HISTORIC AND DESIGN REVIEW COMMISSION

April 17, 2019

HDRC CASE NO: 2019-174
ADDRESS: 101 LOVERA BLVD
LEGAL DESCRIPTION: NCB 9003 BLK 15 LOT 34 AND 35
ZONING: R-4,H
CITY COUNCIL DIST.: 1
DISTRICT: Olmos Park Terrace Historic District
APPLICANT: Brent Bell
OWNER: Brent Bell
TYPE OF WORK: Installation of vinyl shutters, porch railing and column modifications
APPLICATION RECEIVED: March 27, 2019
60-DAY REVIEW: May 26, 2019
CASE MANAGER: Stephanie Phillips
REQUEST:

Basic look of the color combination of siding and trim colors.

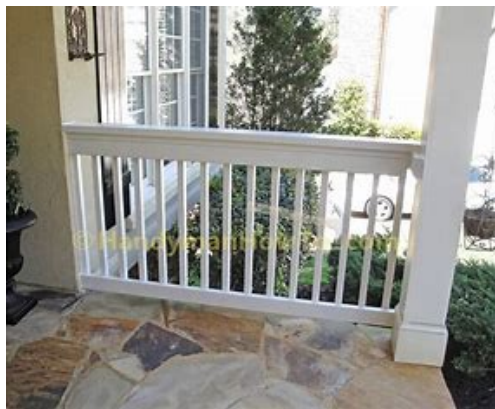
- d. SHUTTERS – The applicant has proposed to install vinyl shutters on the existing windows on the home. The applicant has not provided specifications, but has provided a sketch of the location and general proportions. According to the Historic Design Guidelines, shutters should only be incorporated where they existed historically and where appropriate to the architectural style of the house. Shutters should match the height and width of the opening and be mounted to be operational or appear to be operational. Traditionally in San Antonio, Minimal

Traditional homes of this era did not feature shutters. The incorporation of wood window screens was common to achieve air flow and limit sun exposure into the interior of the home in lieu of shutters. Many of the windows have been replaced over time, but based on the historic development pattern of the district, the original windows were likely one over one, constructed of wood, and featured the installation of window screens. The configuration of the front façade windows does not allow for the space for proportionately appropriate window screens. The installation of vinyl shutters is not stylistically, functionally, or historically appropriate.

Item 3, staff does not recommend approval of the shutter installation based on finding d.
